APPLICATION NO.	FILING DATE	FIRST NAMED INVENTOR	ATTORNEY DOCKET NO.	CONFIRMATION NO.
10/520,541	01/04/2005	Alain Virgl	15675P566	9359

Office Action Summary

10/520,541

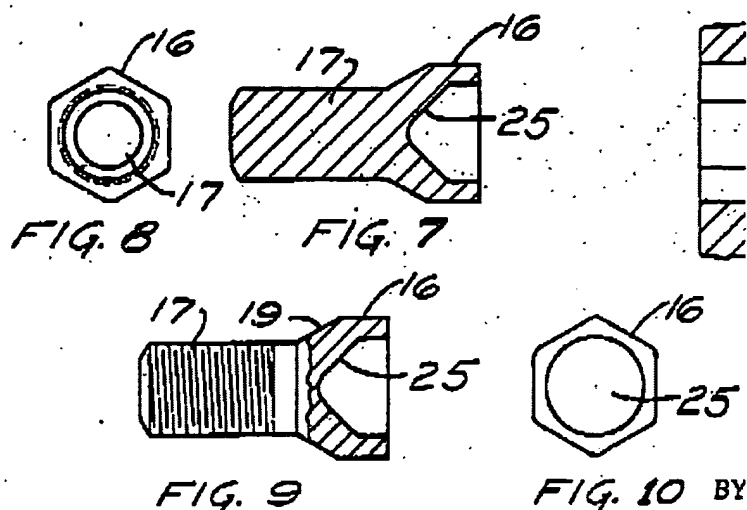
Also, claim 3 is unclear due to antecedent basis. Line 4 recites "its diameter". What is "its" -- the screw diameter (which would be considered the shaft diameter) or the head diameter? Since "it" in line 2 refers to the screw, examiner assumes "its" in line 4 also refers to the screw -- that is, the shaft.
